NUCLEAR REGULATORY COMMISSION

Title: Advisory Committee on Reactor Safeguards
Materials and Metallurgy & Plant Operations
Subcommittee

Date: Friday, April 2, 2004

The purpose of this meeting is to discuss the proposed bulletin regarding pressurize dissimilar metal weld cracking issues.

Inconel Alloy 600
Heater Sleeve

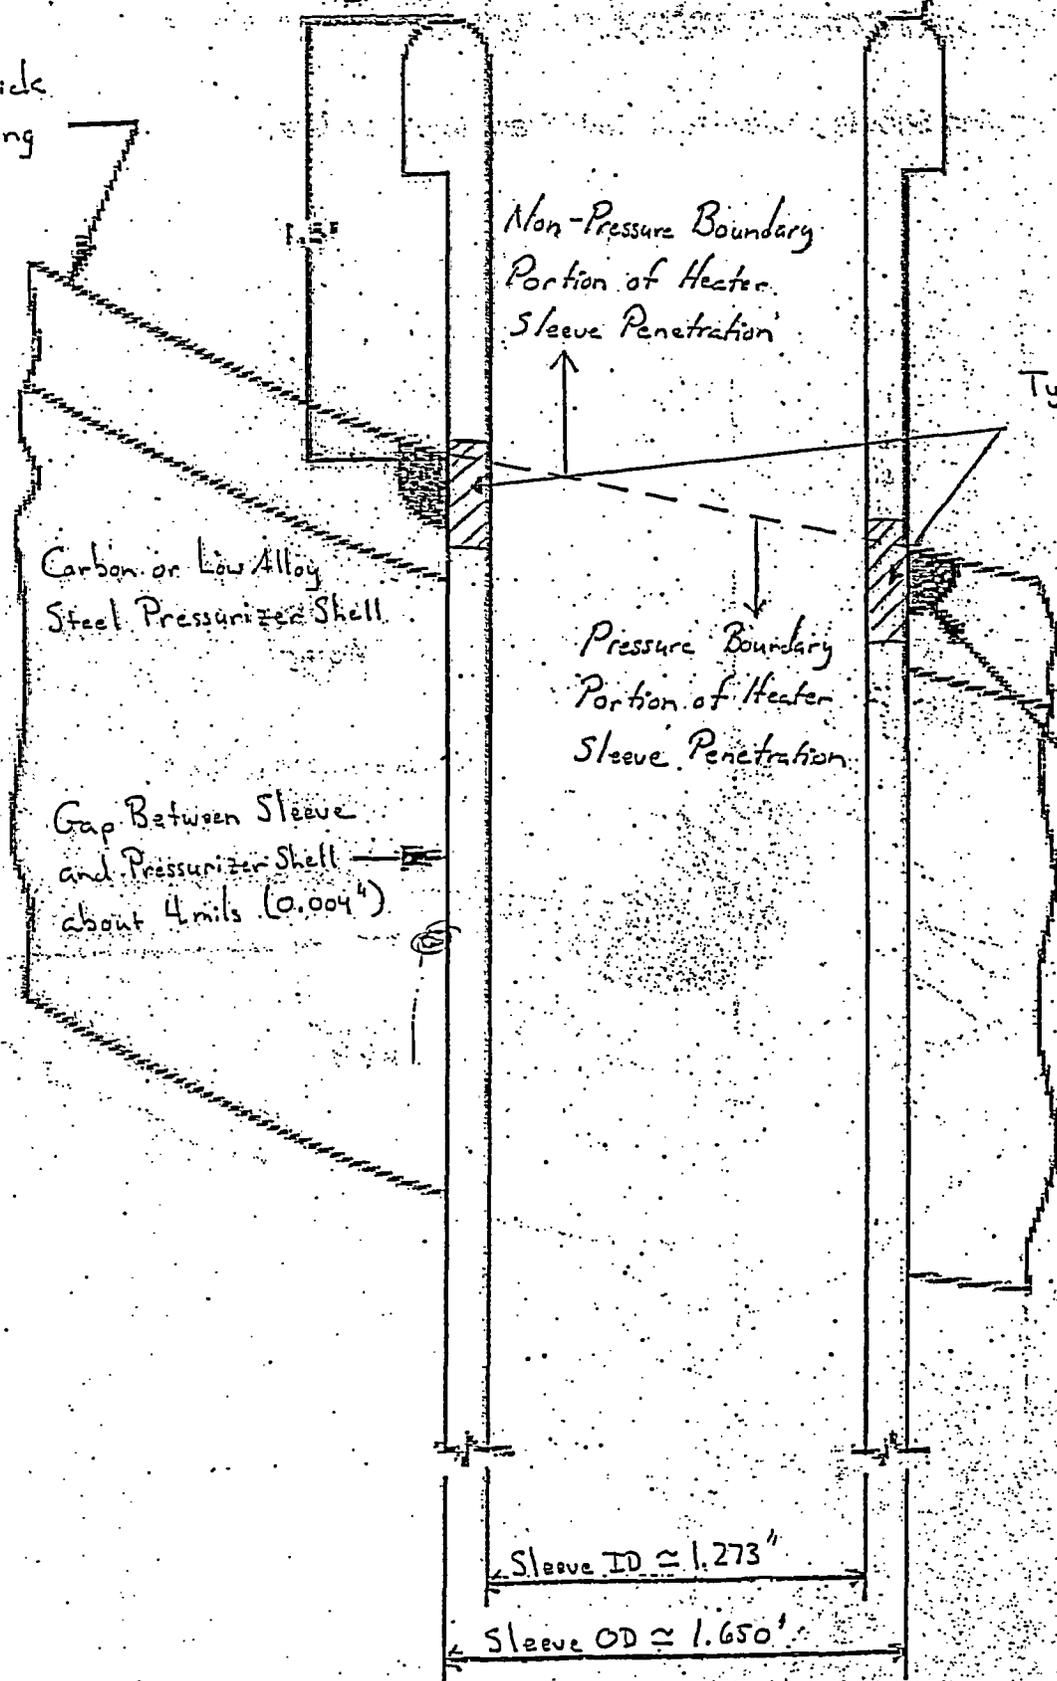
21 And in fact, I believe this drawing did
22 actually come from Palo Verde during the time when we
23 were discussing the indications they found last fall,
24 and so the circumferential cracking that we're
25 discussing would have been above that elevation of a

1 dashed line that you see drawn across sort of the
2 middle of the picture. It's above that. So it would
3 have been in the non-pressure boundary portion.

11 MR. MITCHELL: So your dashed line here is
12 where I've tried to sort of point out the difference
13 between pressure boundary and non-pressure boundary
14 portions.

19 CO-CHAIRMAN FORD: Now, if you're getting
20 cracking at that heat affected zone, why couldn't you
21 get cracking at the lower heat affected zone?

1 is in large part the reason why we are pursuing this
2 proposed bulletin. There would be reason to believe
3 that you would, of course, be potentially susceptible
4 to circumferential cracking below the weld.

12 The best characterization that the
13 industry has provided for us is that they had believed
14 the cracking observed at Palo Verde Unit II may very
15 well have been OD initiated. On the downhill side all
16 of the cracking observed at Unit II was on the down
17 slope side of these penetrations. So it's at this
18 location.

1 analyses, then it was apparent that those results
2 indicated that it would have been potentially more
3 likely to have been OD initiated due to slightly
4 higher stress on the OD.

17 MR. MITCHELL: Well, indeed, based upon
18 those analyses, there were also tensile stresses below
19 the weld on the ID surface. So that would make you
20 potentially susceptible to PWSCC below the elevation
21 of the weld, yes.
